July 13, 2018

ADDENDUM NO. 1

**ROBLES-CASITAS CANAL
RICE BRIDGE REPLACEMENT PROJECT
Specification No. 18-401**

ROBLES-CASITAS DIVERSION CANAL
STA. 24+05.47 TO STA. 298+98±
CANAL SECTIONS AND LINING DETAILS

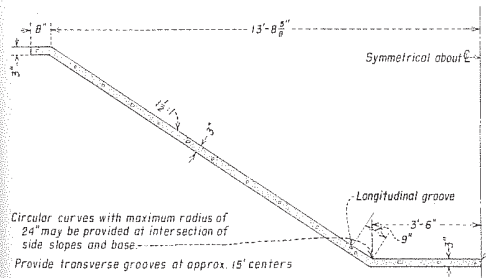
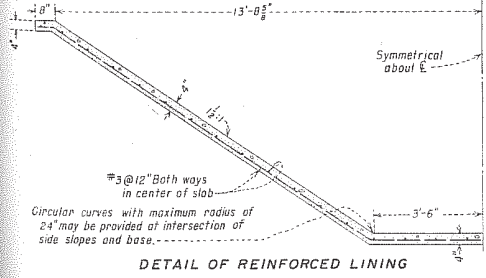
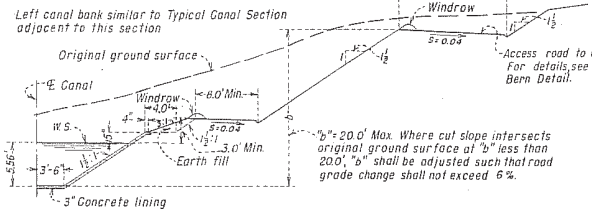
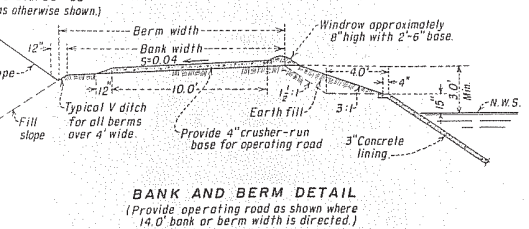
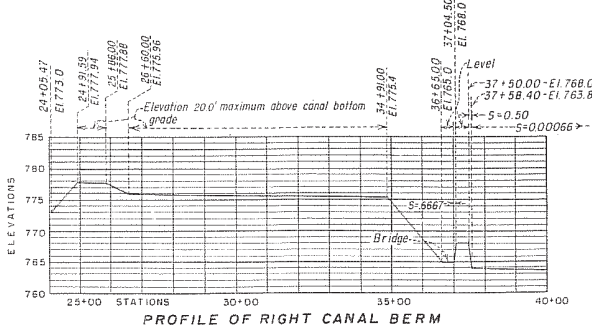
10. Q: *Can you provide as-built drawing of the existing channel at the location of the existing crossing?*

A: The as-built drawing is attached to this Addendum (Drawing No. 767-D-133)
